**TOWN OF PORTOLA VALLEY
ARCHITECTURAL AND SITE CONTROL COMMISSION (ASCC)
Monday, February 24, 2014
7:30 PM – Regular ASCC Meeting
Historic Schoolhouse
765 Portola Road, Portola Valley, CA 94028**

MEMORANDUM

RE: Continued review for conformity with CUP X7D-30 and for Site Development Permit X9H-668: New building at Benedictine Square and proposed changes to Benedictine and Church Squares

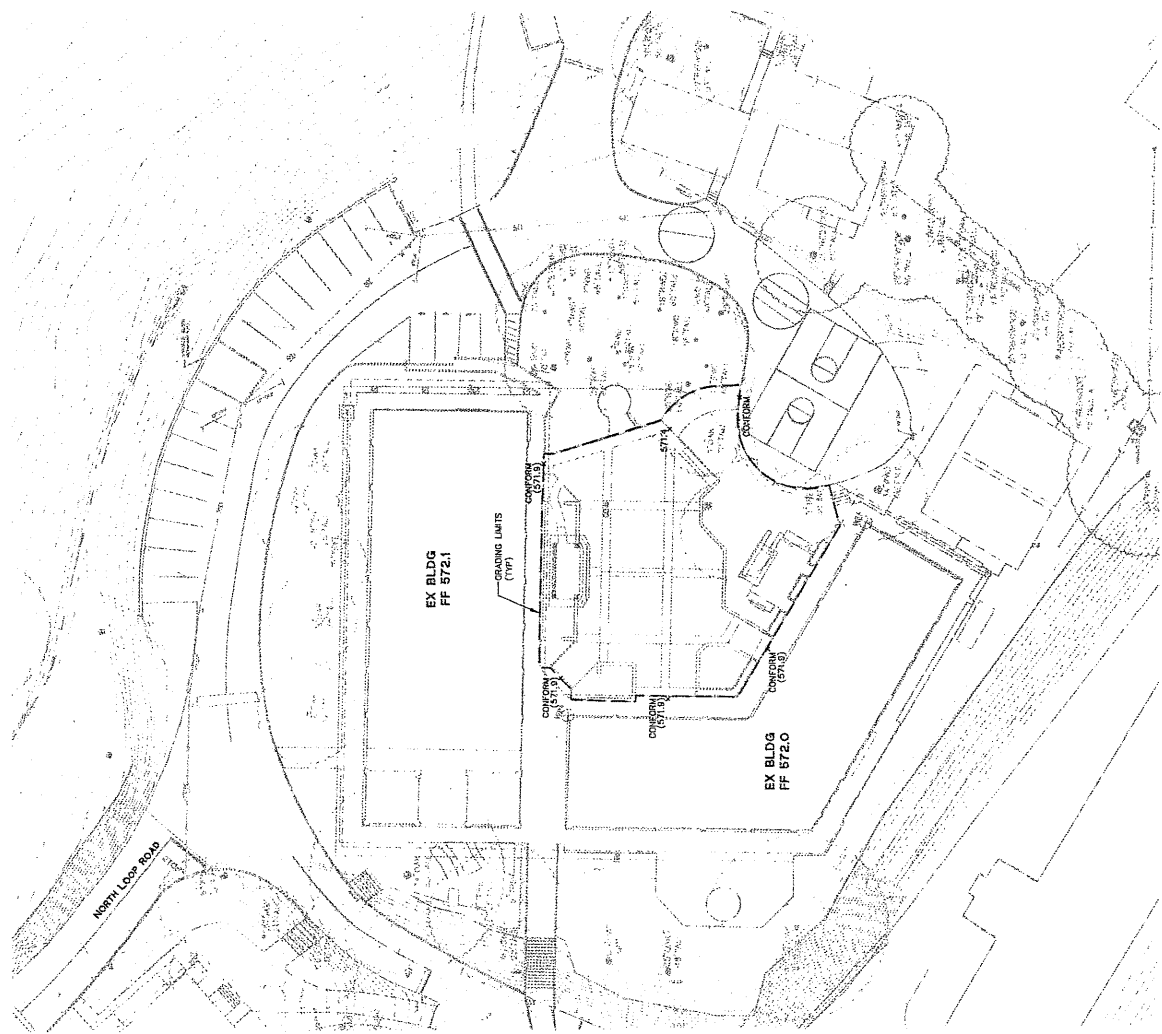
2. **Site Development Permit, Storm Drainage, and Project Staging.** Conceptual grading plans are provided on Sheets C3.0 (Benedictine Square), C3.1 (Church Square), and C3.2 (Portable Building A Relocation). These grading plans show less grading than was anticipated at the last meeting. However, the plans do not appear to include the grading for the wheelchair ramp at the north end of the Student Center and may be missing other items as well. Submittal of engineered grading plans and approval by the Public Works Director, Town Geologist, and Fire Marshal will be necessary before the site development permit could be issued.

Although the grading plans provide total earthwork numbers, these do not appear to account for the work that will be needed to remove the current pavers and install nine inches of drain rock under the new pavers. This volume of earthwork will need to be accounted for in the construction staging plan for the project. In addition, the construction staging plan will need to demonstrate coordination with the construction staging plan for the track and field project. The two staging plans will need to show that there is sufficient on-campus parking for all construction workers throughout both projects, as well as appropriate storage areas for materials that are being removed and brought in for both projects, and both will need to identify and address any potential impacts on traffic. Timing relative to normal school year site demands will be an important consideration for the applicant and for the Town in reviewing and acting on the final construction staging plan. The final plan should include a detailed time schedule developed by the project architects and construction contractors.

4. Engineered grading plans that are in substantial conformity with the conceptual grading plans shown on Sheets C3.0, C3.1, and C3.2 shall be provided prior to the issuance of a site development permit and shall be to the satisfaction of planning staff and the Public Works Director.
